Issue 15.

1st January, 1953.

CONTENTS

**RUMBOLD SAFETY BELTS, TYPE M.192 (ISSUE 4)
AND M.368 (ISSUE 3)**

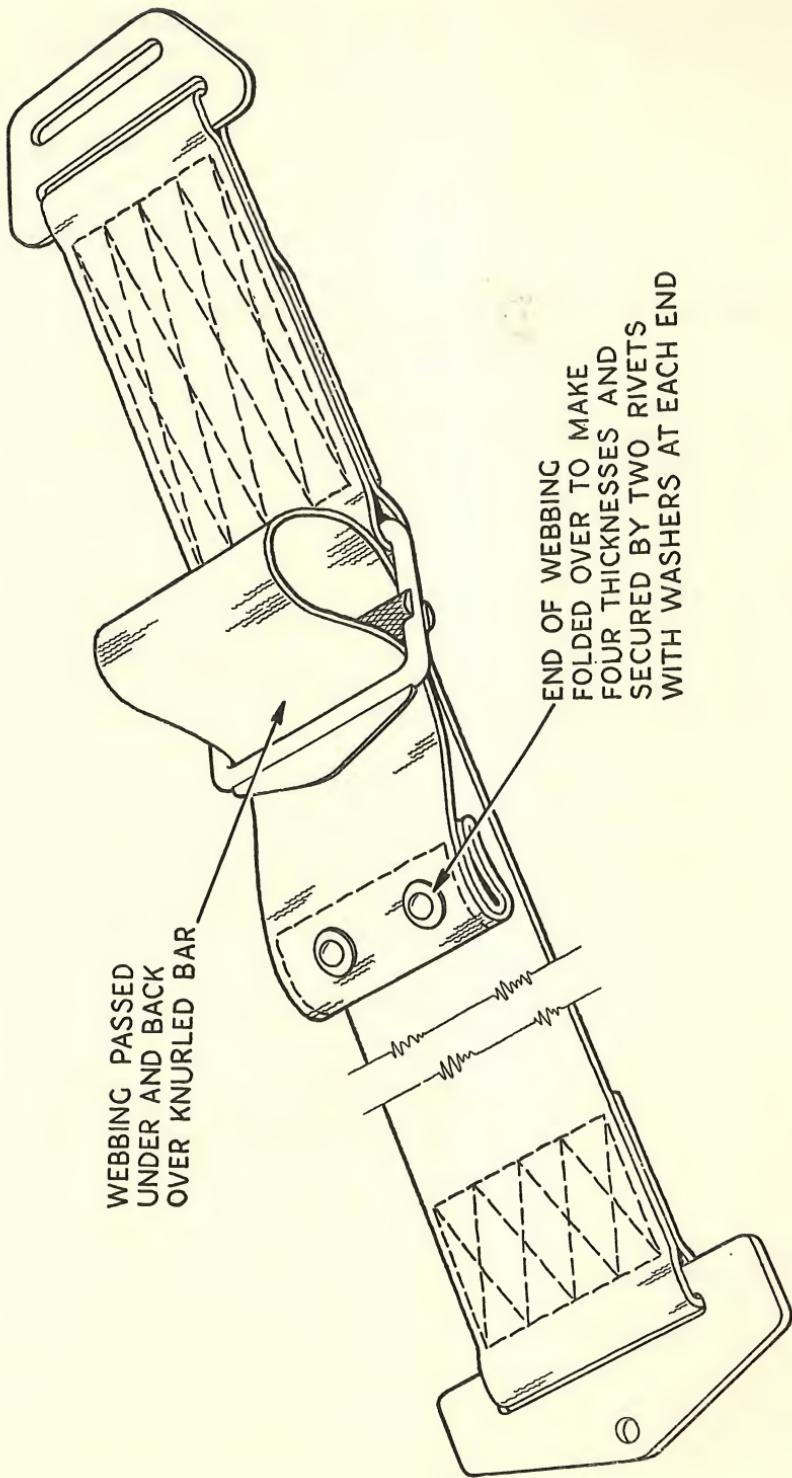
- 1 Instances have occurred of the above-mentioned belts being wrongly assembled in relation to their adjuster mechanisms. In such instances, it is possible for the belt to slip through the adjuster when a load is applied, instead of being held fast as it will be if the assembly is correct.

- 2 The correct method of assembling the belt in relation to the adjuster is illustrated overleaf. As early as convenient, but in any case not later than the next minor inspection, all belts of the above types must be inspected to ensure that their adjuster assemblies conform with this illustration.

- 3 After ensuring that the assembly is correct, the tongue end of the belt is to be doubled over to make four thicknesses and then secured by rivets with washers at each end as illustrated ; or, as an alternative to the rivets and washers, the four thicknesses may be stitched together. This modification is intended to prevent subsequent alteration of the adjuster assembly.

FIGURE 1

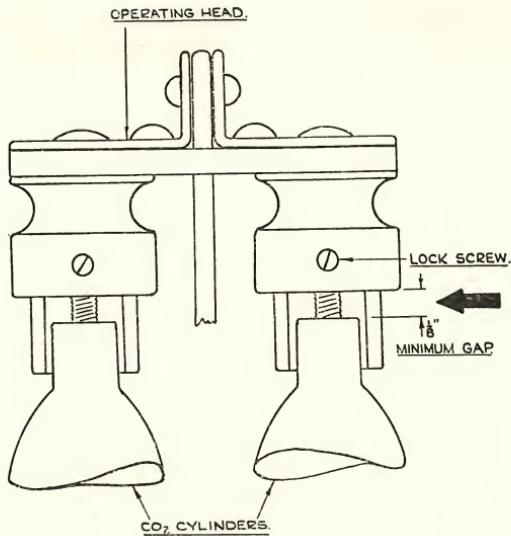
1.1 Remove the CO₂ assembly from the jacket and check the clearance between the bottle-neck and holder, as illustrated in Figure 1, overleaf.

1.2 Check that the lock screw is only sufficiently tight to prevent rotation of the bottle.

FIGURE 2

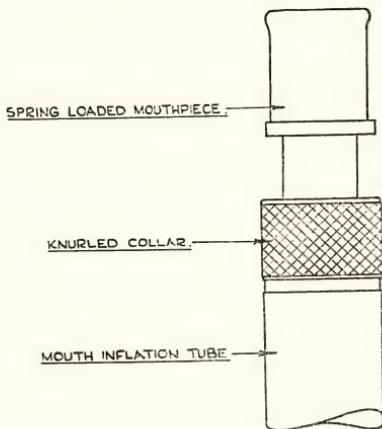
2 Mouth Inflation Assembly The Type 47 Mark 2 has a metal mouthpiece which is locked by means of a knurled collar. To facilitate the use of this assembly the following action is to be taken forthwith.

2.1 Tighten the knurled collar down fully to the position shown in Figure 2, overleaf.

2.2 As a temporary measure amend the printed instructions (using a copper-free ink) on the label alongside the mouth inflation assembly so that they appear as follows :—
